**The Great Grid Upgrade**

Grimsby to Walpole

Addendum to the Strategic Options Report

January 2024

Figure 6.1 – ECO 6 - new Grimsby West to new Lincolnshire Connection substation(s), new Lincolnshire Connection substation(s) via new Weston Marsh to new Walpole

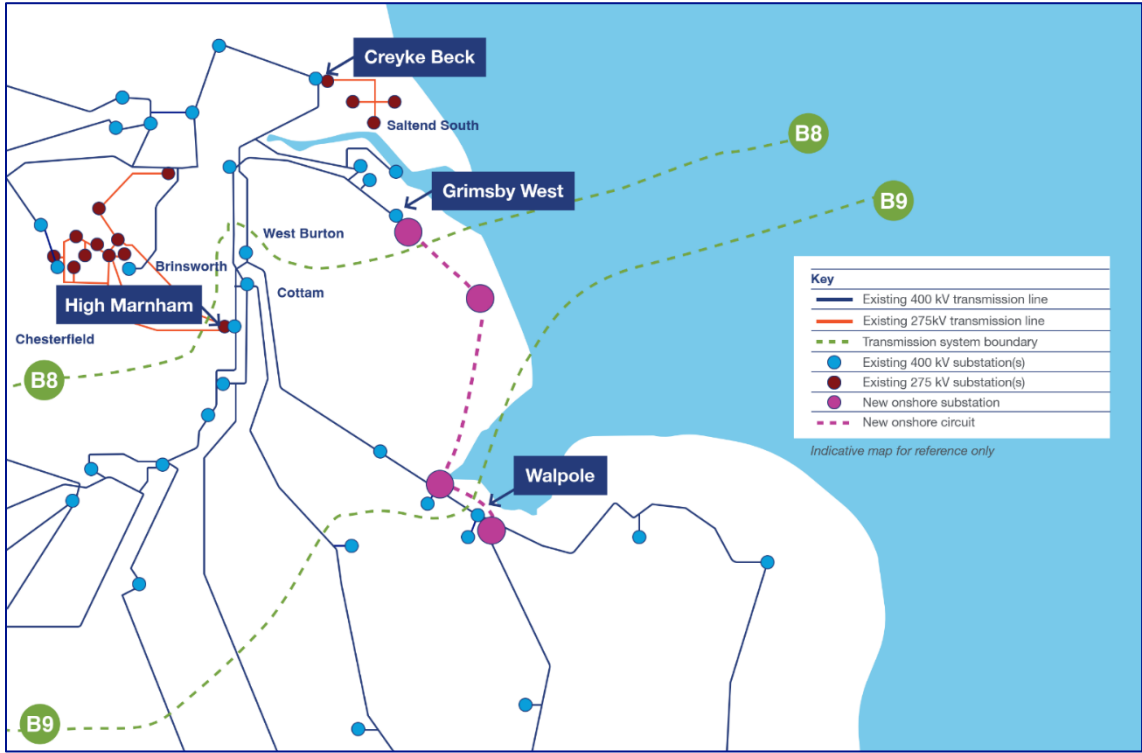
- 6.6 Option ECO 5 therefore no longer meets the need case for the Grimsby to Walpole project, whereas ECO 6 does. As a result, the preferred onshore option is now ECO 6.

- 6.9 For the above reasons, ECO 6 now represents the most advantageous strategic option for the Project, when balancing cost, technical performance, environmental and socio-economic differentiators. NGET is therefore proposing to take forward ECO 6 as the preferred option.

- 6.10 Figure 6.1 below shows the proposed option ECO 6 “Grimsby to Walpole” project.
